Davis-Besse Nuclear Power Station, Unit No. 1
Docket No. 50-346, License No. NPF-3
Response to Request for Additional Information Regarding
License Amendment Request to Revise Emergency Diesel Generator
Minimum Voltage and Frequency Surveillance Requirements (TAC No. MF6060)

Response to September 21, 2015 Request for Additional Information
Page 1 of 5

Figure 3-7. Voltage and Frequency Response for EDG Design Basis LOOP/LOCA with Hot Field – Case 7

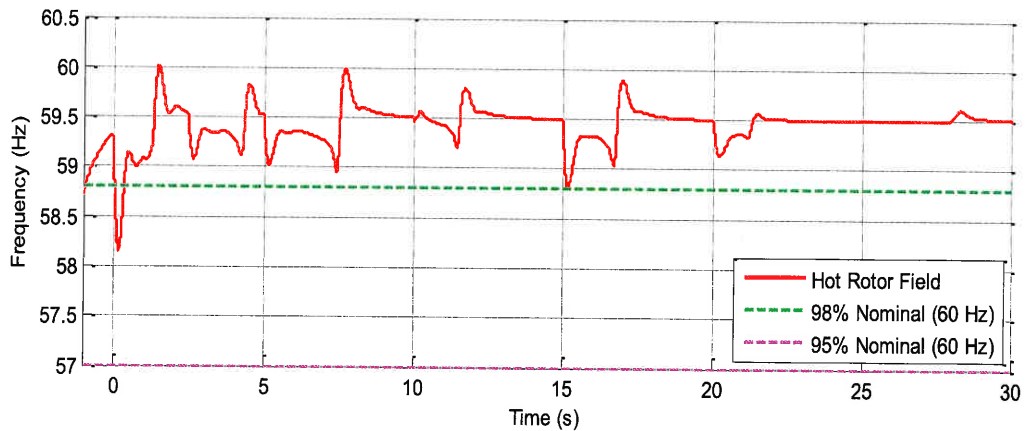
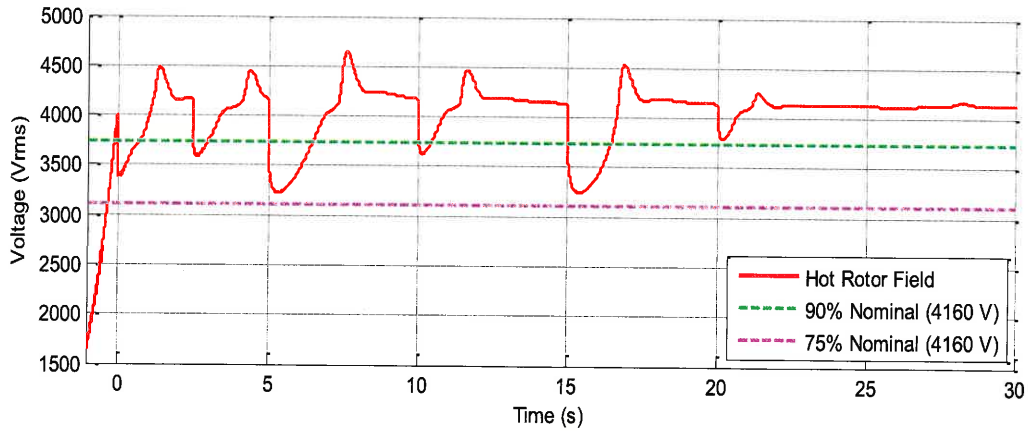
Explain how the evaluation performed demonstrates that the voltage drop (Attachment H of the LAR) during this stage of EDG loading satisfies Safety Guide 9 criterion and the minimum voltage required for running equipment.

Attachment H of the license amendment request (LAR) documents an emergency diesel generator (EDG) transient loading analysis that is based on equipment operability limits. This document does not demonstrate that the Safety Guide 9 criterion is met. Rather, "Evaluation of Davis Besse EDG Transient Response During Design Basis LOOP/LOCA, LOOP Only and Appendix R Loading," (hereafter referred to as the EDG Transient Response Analysis) demonstrates that the Safety Guide 9 acceptance criterion is satisfied with the EDG breaker closing at its permissive setpoint of 3990 volts (V) with a voltage set point of 4088 V. The proposed allowable voltage of 4070 V considers a setpoint of 3990 V with a maximum relay setting tolerance of 2 percent. Excerpts from the EDG Transient Response Analysis applicable to the voltage setpoint are provided in Appendix 1.

Figure 7-17. Voltage and Frequency Response for EDG Design Basis LOOP/LOCA with Hot Field – Case 7

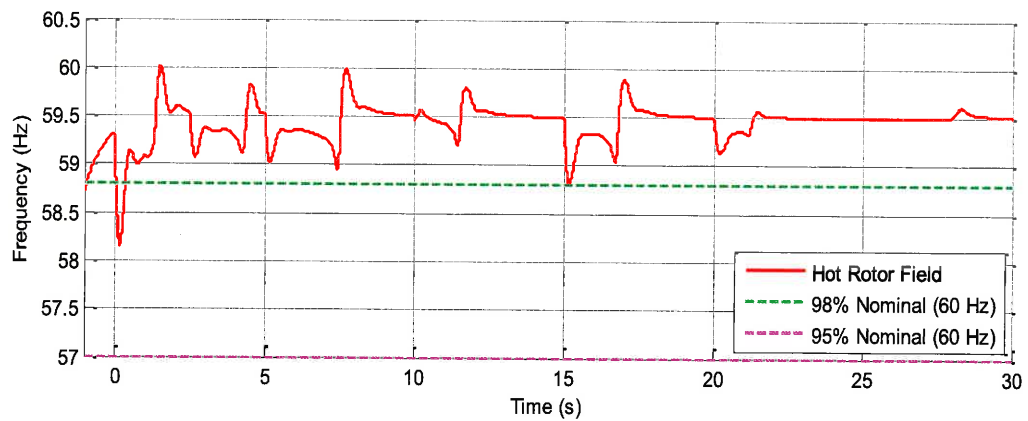
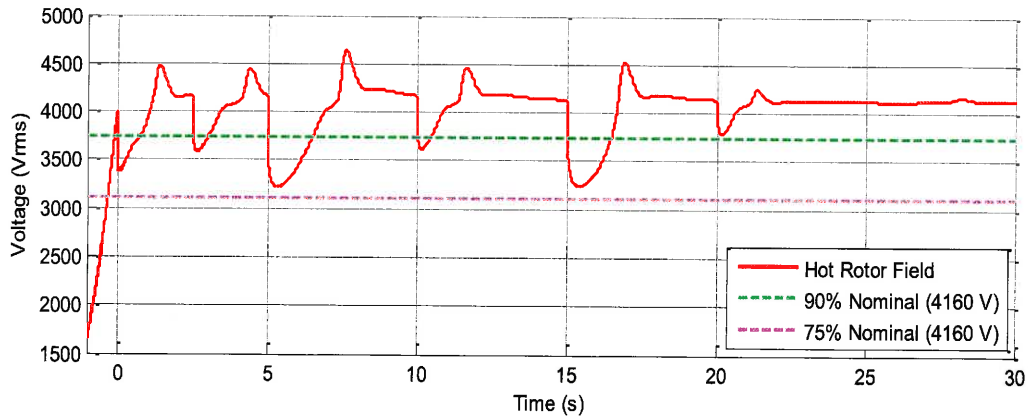
Provide a summary of the EDG frequency and voltage response in a tabulated form with assumptions made for starting voltage and frequency.

The EDG Transient Response Analysis provides a summary of the EDG frequency and voltage response in Table 7-15, "Summary of Results for Design Basis LOOP/LOCA Analyses – Case 7," and Table 7-18, "Summary of Results for Design Basis LOOP/LOCA Analyses – Case 8." These tables are provided in Appendix 1. EDG Transient Response Analysis, Section 4.1, "Assumptions," describing starting voltage and frequency assumptions, is provided in Appendix 5.

Figure 3-5. Voltage and Frequency Response for EDG Appendix R- MDFP Start

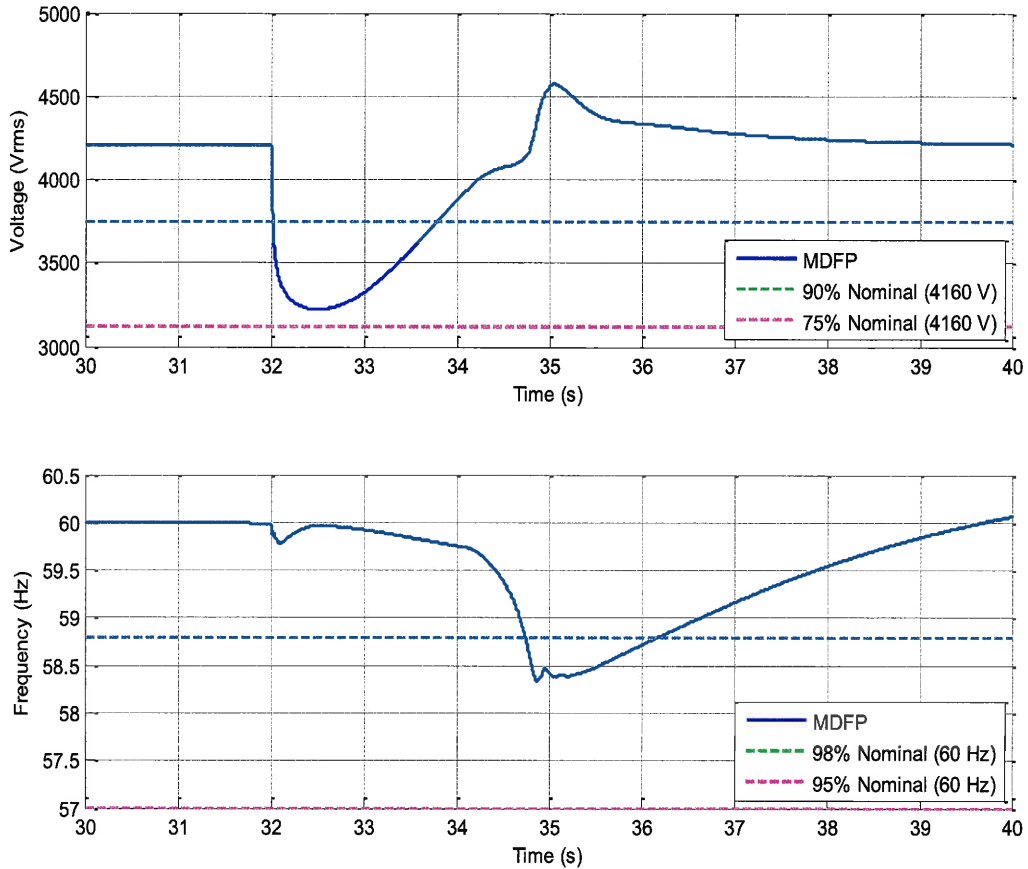
Provide a summary of the assumptions, methods, and results of the evaluation performed to demonstrate that the voltage drop in the auxiliary system will not adversely impact safety-related equipment if the EDG was operating at the steady state voltage of 4088 V prior to pump start.

prior to manually starting the motor driven feedwater pump (MDFP). The EDG Transient Response Analysis does not evaluate the MDFP starting at a voltage of 4088 V. Rather, the analysis evaluates starting of the MDFP motor on the EDG with a nominal voltage of 4200 V. The analysis (Appendix 3) concludes that the EDGs are capable of starting the MDFP and that the minimum requirements for voltage (75 percent nominal, based on 4160 root mean square voltage) and frequency (95 percent nominal, based on 60 Hertz [Hz]) are met at this voltage level. The methods used to perform the analysis are described in Appendix 2 whereas the assumptions are provided in Appendix 5.
